HISTORIC AND DESIGN REVIEW COMMISSION

HDRC CASE NO: 2023-191

ADDRESS: 1223 S ALAMO ST **LEGAL DESCRIPTION:** NCB 750 BLK 9 LOT 6

TYPE OF WORK: Construction of a solid fence parallel to Madison Street

ELEVATION: 6'-0" WOOD PRIVACY FENCE

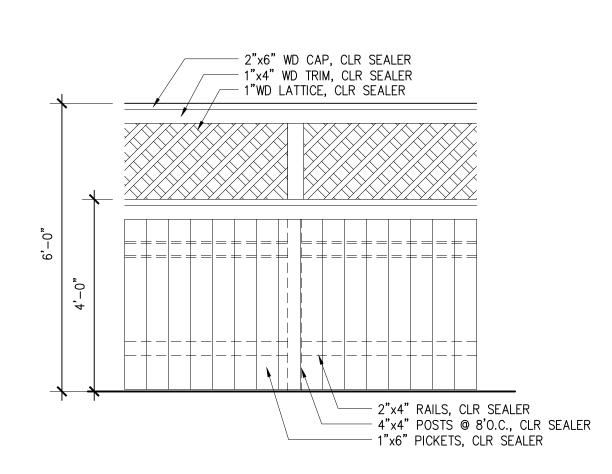
- d. FENCING The Guidelines for Site Elements 2.B. notes that new fences and walls should appear similar to those used historically within the district in terms of their transparence, scale and character. Additionally, the Guidelines note that the height of fences within the front yard should be limited to four (4) feet in height and that privacy fencing should not be located within front yards. As noted in finding b, this lot features frontage to Madison Street. Solid fencing of any height if not found historically fronting Madison Street. Staff finds that fencing, such as the existing wrought iron fence, should be maintained as this fencing is consistent with historic examples found within the district.

Staff does not recommend approval based on findings a through d. Staff finds that the existing wrought iron fence be maintained in place.

SITE PLAN: PROPOSED

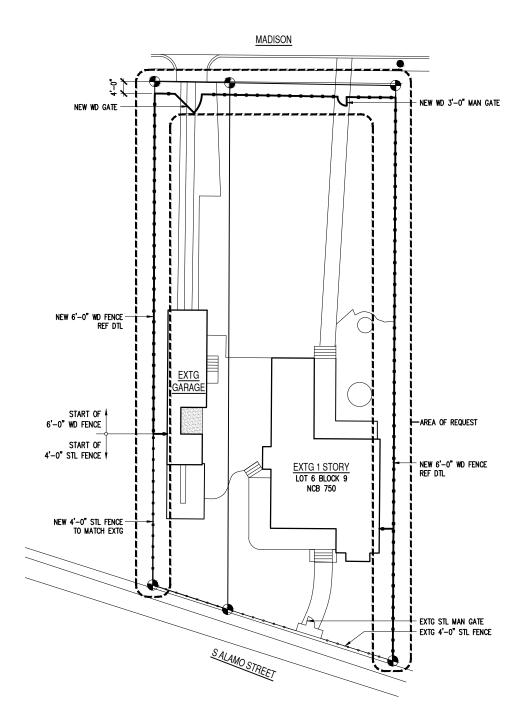
- b. LOT CONFIGURATION As noted in finding a, the lot at 1223 S Alamo features frontage to both S Alamo Street and Madison Street. On Madison Street, the lot to the immediate north, 514 Madison Street, features frontage to Madison. A wrought iron fence with a brick base has been in place parallel to Madison Street at 1223 S Alamo.

- c. PREVIOUS REVIEW/VIOLATION At the July 20, 2022, Historic and Design Review Commission hearing, the Commission approved privacy fencing along the side property lines only. Replacement of the existing fencing was not approved; neither was the installation of solid fencing in front of the existing fence. A solid fence featuring approximately forty-eight (48) inches in height was installed parallel to Madison Street in April 2023, without a Certificate of Appropriateness. This request proposes an additional two (2) feet of a wood lattice element would be added atop the existing, unapproved fence.
